Product Quality Notice

Notice number: **PQN-2**

Affected product: **GB142 Gas Condensing Boiler**

Subject: **Quality Improvements on Spare Parts**

Figure 1

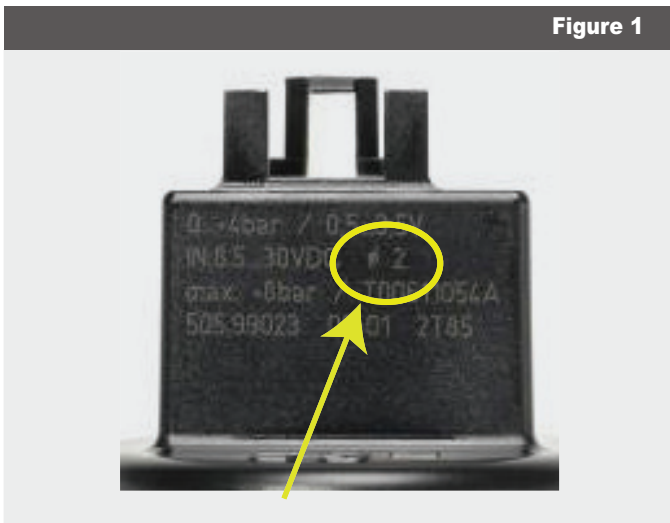
- **Problem description:**
Due to dirt accumulating in the measuring hole of pressure sensor, the failures "2L-266/328" and "CO -288" can occur on the display.
- **Product Improvement:**
Diameter of measuring hole increased from 0.9mm to 2.0mm. The new pressure sensor can be recognized by the ø2 sign on the spare part (see Fig. 1).

- **Effective Date:**
New Sensor included with boiler starting June 1st 2009.
New Sensor available as a spare part starting June 1st 2009.

Figure 2

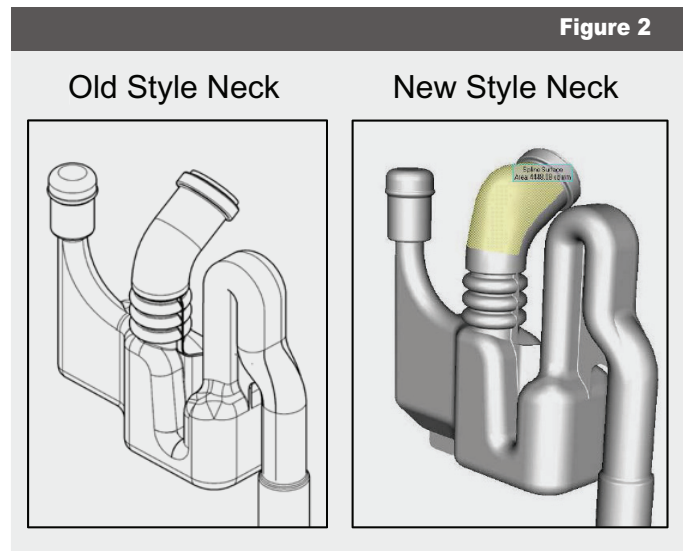
- **Problem description:**
If condensate traps dry out the plastic may crack at the neck. Difficulty removing the trap for maintenance may also unintentionally lead to stress cracking.
- **Product Improvement:**
Material changed to Bralen RB 03-23 known for high environmental stress cracking resistance. Neck design changed to allow ease of removal and prevent unintentional cracking through handling (See Fig. 2).

- **Effective Date:**
Material change – June 2007
Neck Design change – April 2008
- **Field Inventory Action:**
Any condensate traps currently in field inventory with an FD < 7151 (see Fig. 3, how to read FD) may be returned for a replacement. Please call customer service to obtain an RMA. Photo identification of the FD number will be required for credit.
